## Reelmaster® 5500-D

## Subject: Oil from the differential can transfer to the hydraulic system on some units.

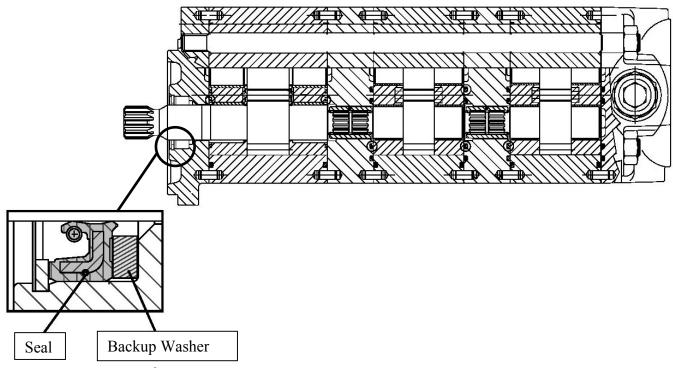
There have been instances where the differential oil is low at the same time the hydraulic system is overfilled. Investigation has revealed that in some instances oil has transferred from the differential to the main hydraulic system. The exact circumstances allowing this to happen to a very small percentage of units are unclear, but it is known that the transfer happens past the seal of the sectional pump.

Should you find that oil in the differential is low and the hydraulic system is overfilled, add or remove oil to correct the fluid levels. Run the machine for a 50-hour period and recheck the levels. If the level in the differential is again low while the hydraulic level increases, replace the sectional pump seal using Seal Kit (104-0576). The seal in this kit will be installed with a backup washer behind it and the lip facing out. Refer to figure below for more information regarding seal orientation.
